EEH/EEB 6100.5 and EEH/EEB 6150.5

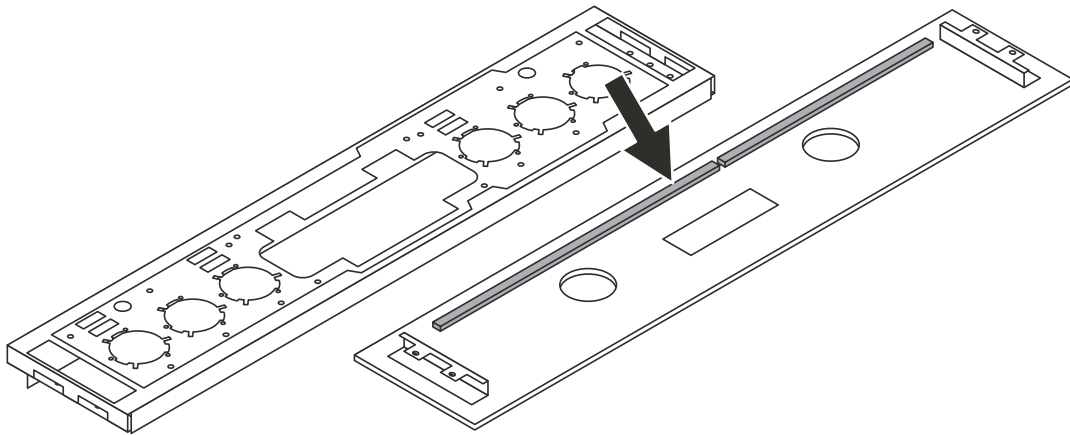
It is possible that the sealing (spare-part no. 535 995) may have been incorrectly glued in if it is no longer possible to adjust the clock (spare-part no. 528 383) with three buttons and the clock (spare-part no. 528 385) with five buttons.

Please proceed as follows to replace the sealing material:

1. Completely remove the foam sealing material on the back of the front pane of glass.

2. Glue new foam sealing material into the groove along the contour of the metal panel as illustrated.
